# Dewberry Response to USGS Review of the Texas West Central Project Block 12 LiDAR Project

Produced for U.S. Geological Survey

USGS Contract: G10PC00020

Task Order:140G0218F0072

Figure 4 – Tile 14SLB705510 – USGS screenshot.

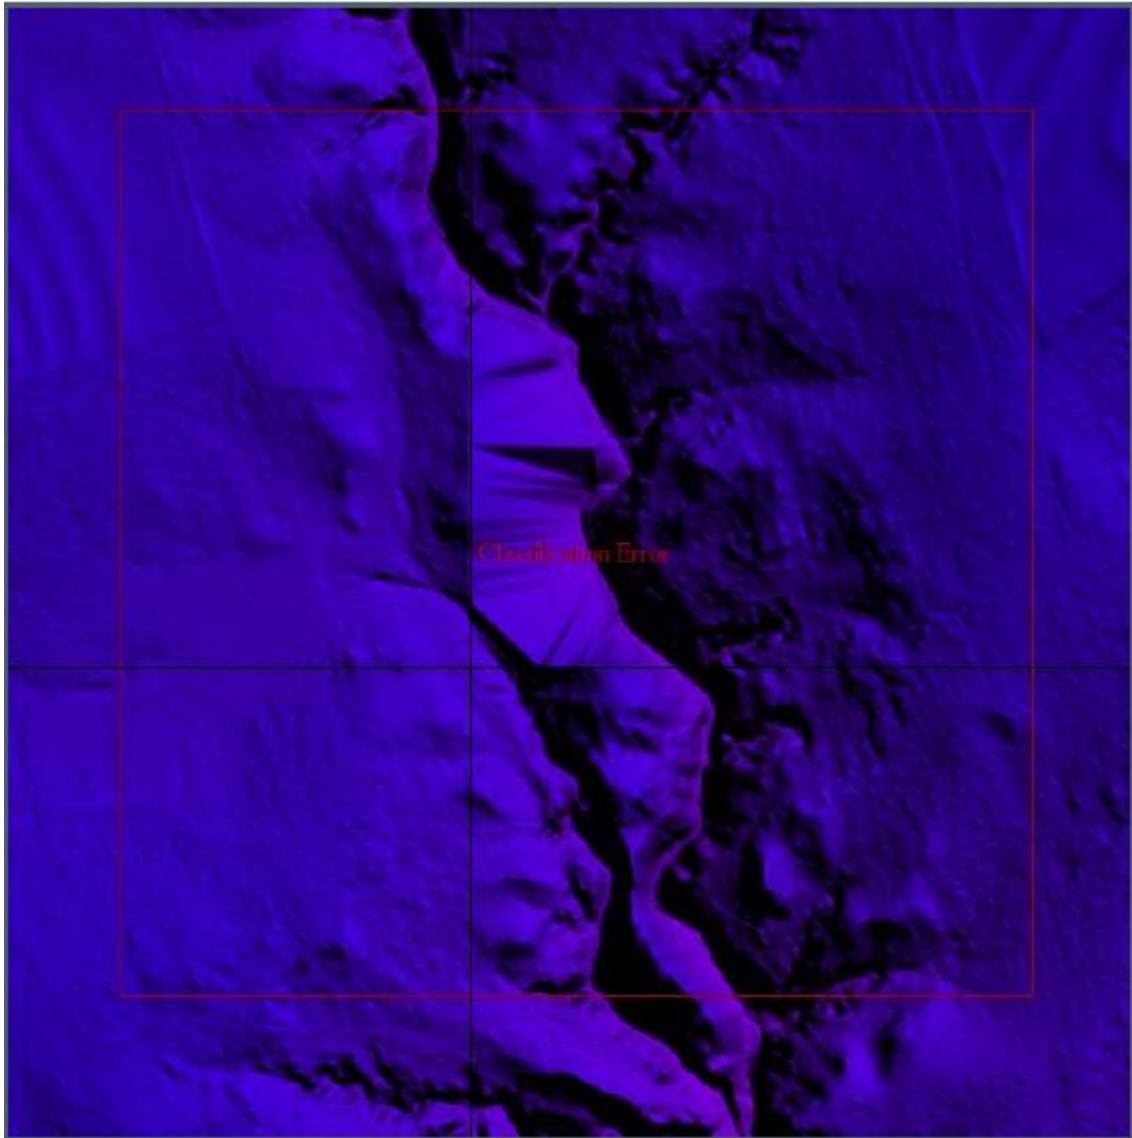
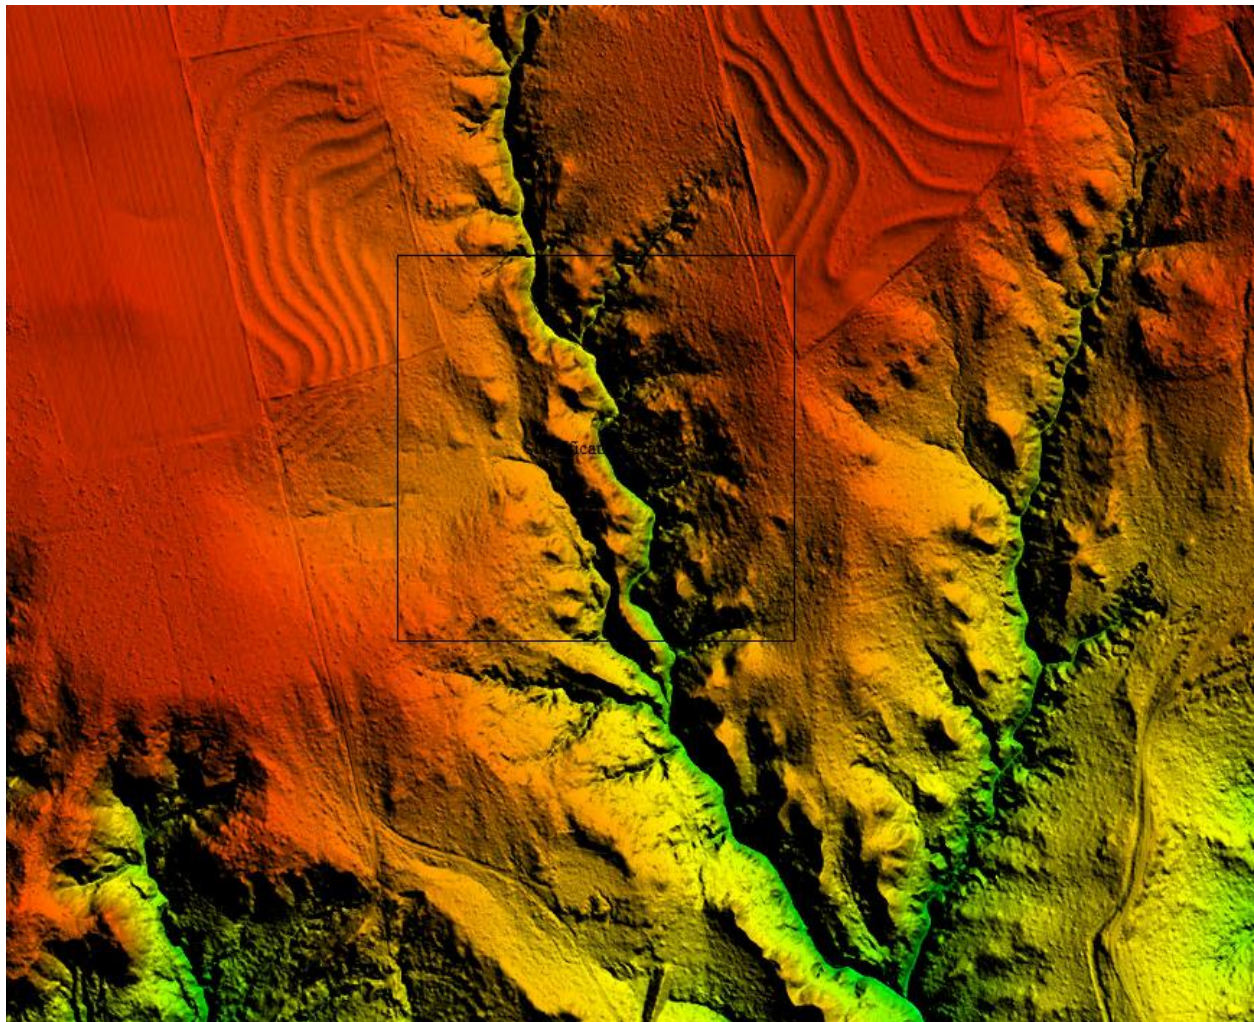
USGS made one data void call where data was missing in Tile 14SLB705510. Dewberry reviewed the tile and added ground where necessary.

Figure 5 – Tile 14SLB705510 – Screenshot showing points have been added back to ground and the DEM has been recreated.

Figure 12 – Tile 14SLB525795 – USGS screenshot.

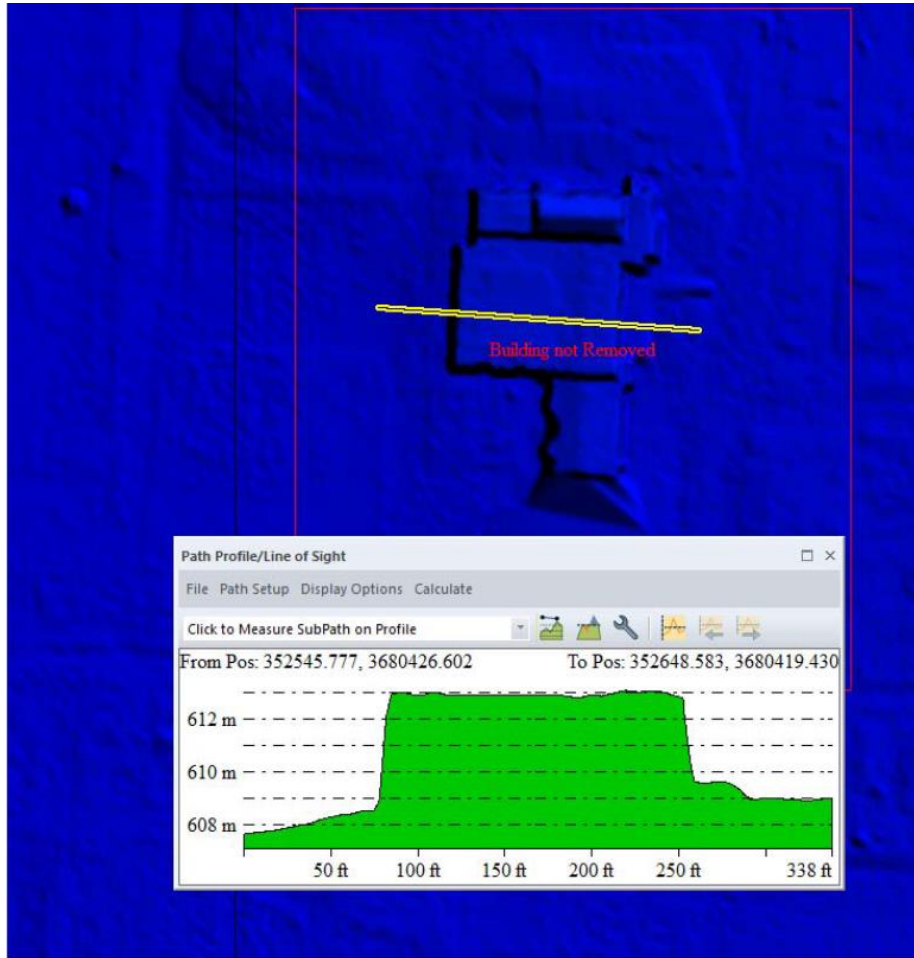
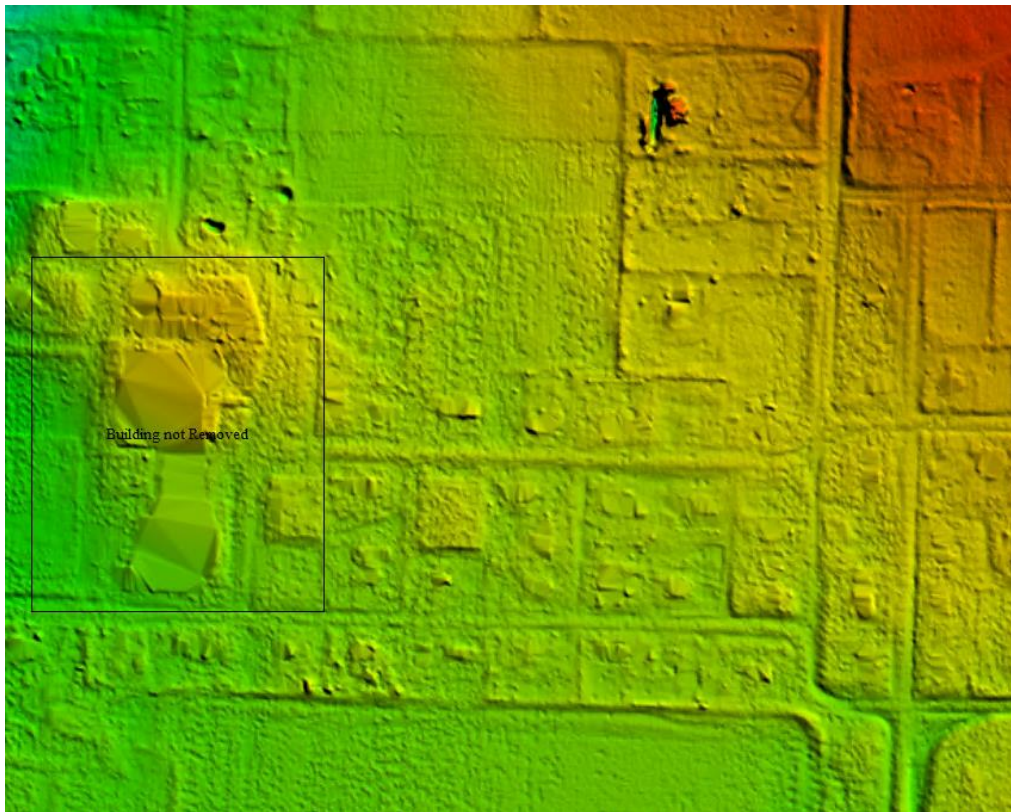
USGS made one call to remove a manmade structure. Dewberry reviewed the tile and removed the structure.

Figure 13 – Tile 14SLB525795 – Screenshot showing building has been removed from ground surface and the DEM was recreated.
